Subject: Docket Nos. 50-361 and 50-362
San Onofre Nuclear Generating Station
Units 2 and 3

Enclosed are sixty-three (63) copies of responses to additional NRC Equipment Qualification Branch questions concerning the seismic qualification of equipment. These responses provide additional information requested by the seismic qualification review team during telephone conversations with SCE and SCE consultants on March 19 and 25, 1981. The remaining information requested will be provided by April 17, 1981.

Response to Questions Raised by NRC in Summary of SQRT Plant Site Review

Response to Additional NRC SQRT Audit Questions

CONTAINMENT PURGE ISOLATION DETECTOR & TRANSMITTER
SEISMIC RESPONSE SPECTRA
SSE, VERTICAL, 1% DAMPING

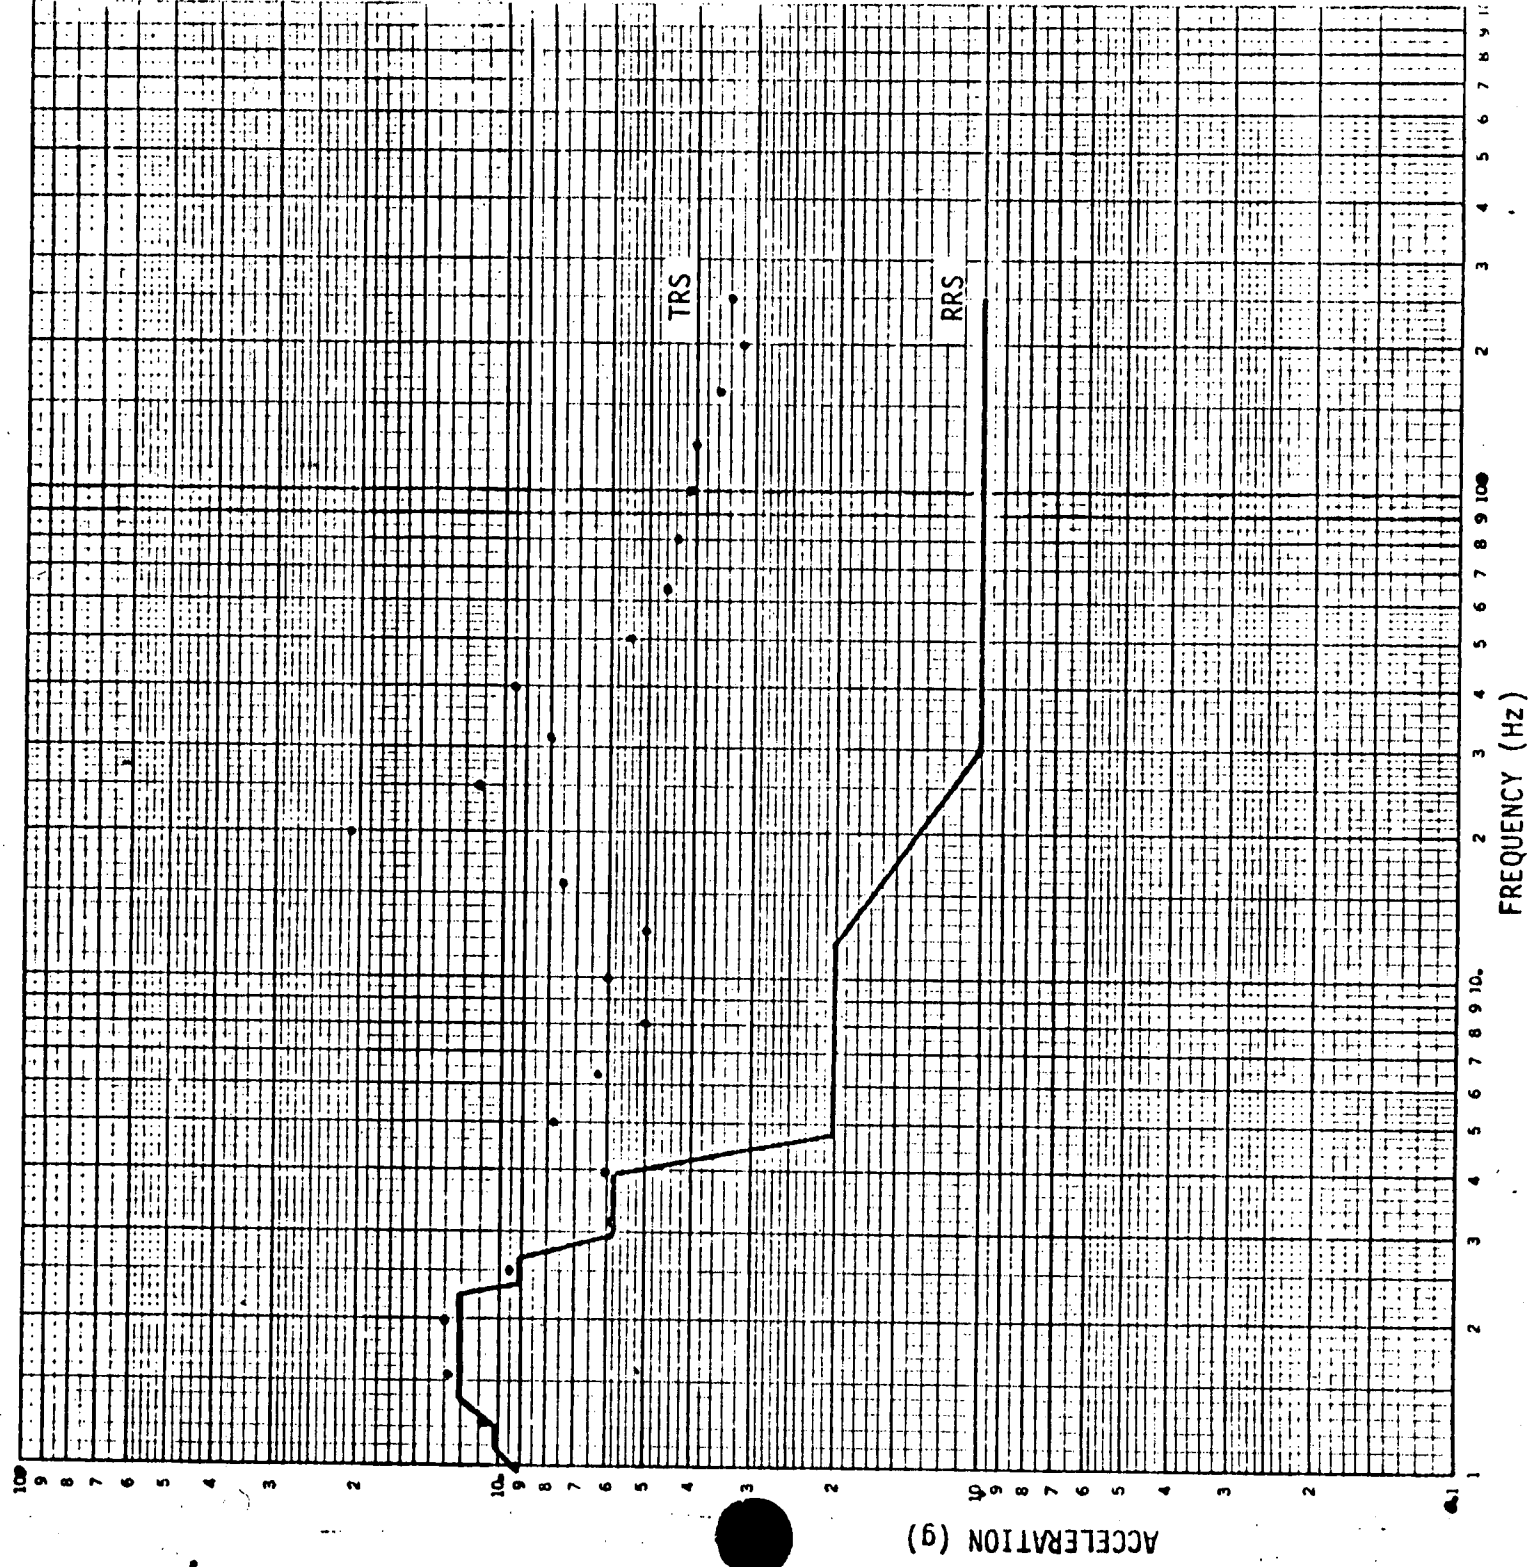
Provide seismic qualification summary forms for the following items; Station Batteries (BOP 5), Controllers (NSSS 10), Containment Purge Radiation Detectors (NSSS 21) and Containment Purge Radiation Transmitters (NSSS 22)

Attached you will find copies of the requested seismic qualification summary forms. The forms for BOP-5 are for the in-place Exide Model G batteries which have a limited qualification life (3.9 yrs). We plan on replacing these batteries with the Exide Model GN batteries once the current qualification program has been completed. The current forecast for completion of this program is July 27, 1981 with a forecast completion of the revised seismic qualification summary forms by October 2, 1981.
